# XPS-Q8

## Universal High-Performance Motion Controller/Driver

**Release Note**

**V1.4.x**

Figure 1.b: Home directory of Administrator user on XPS-Q8 controller.

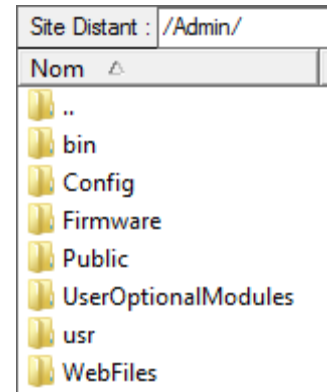
When connecting to an XPS-Q8 controller with the new generation firmware, the home directory for the Administrator (figure 1.b) includes new folders *bin* and *usr* which contain system files; *Config* is equivalent to the previous *CONFIG* folder. The Administrator can access and modify three folders: *Config*, *Public* and *UserOptionalModules*.

Figure 3: Public directory content of the XPS-Q8 controller

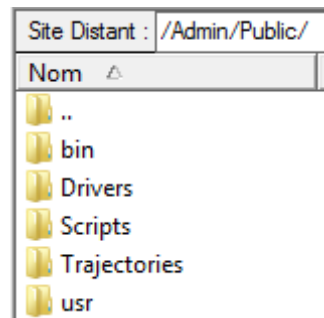
*bin* and *usr* are new folders added to the *Public* directory which contains system files; these directories are not to be accessed by the Administrator..

Figure 3.b: Home directory of User on XPS-Q8 controller.

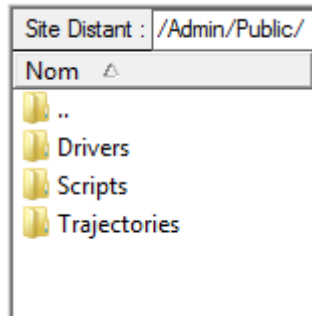
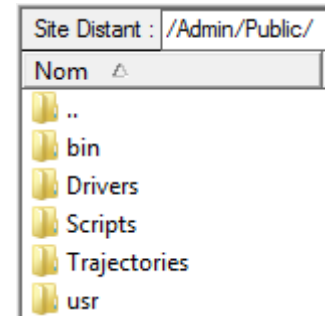
*Public* is the home directory for a User with no Administrative rights when connecting to the XPS-Q8 controller. Two new folders *bin* and *usr* were added to the *Public* directory for the XPS-Q8 controller; see figures 3.a and 3.b below:

*bin* and *usr* directories must not be accessed by a user.

Figure 7b: “IP Management” page of XPS-Q8 controller.

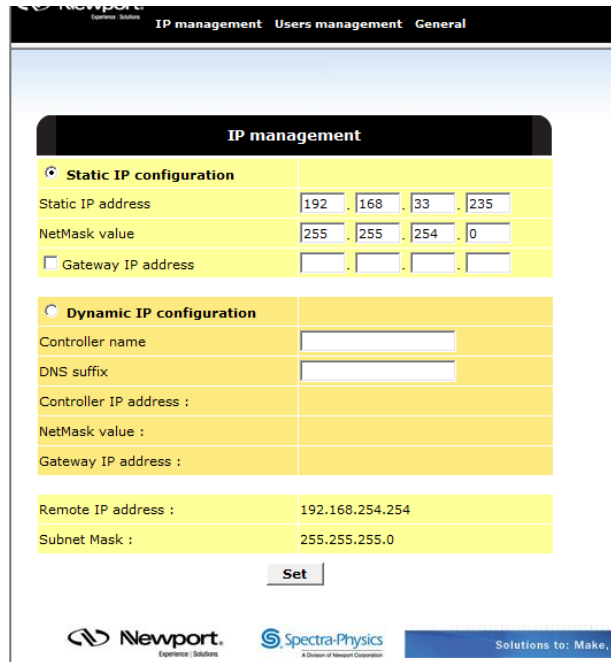
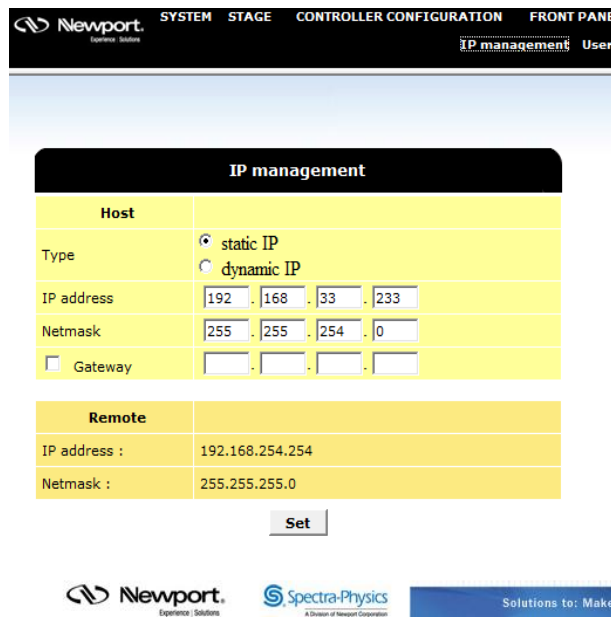
There are some changes to the format of the “IP Management” web page of the new XPS-Q8 controller website, but the functionality of the web page remains unchanged. The different formats are illustrated below in Figures 7a and 7b.
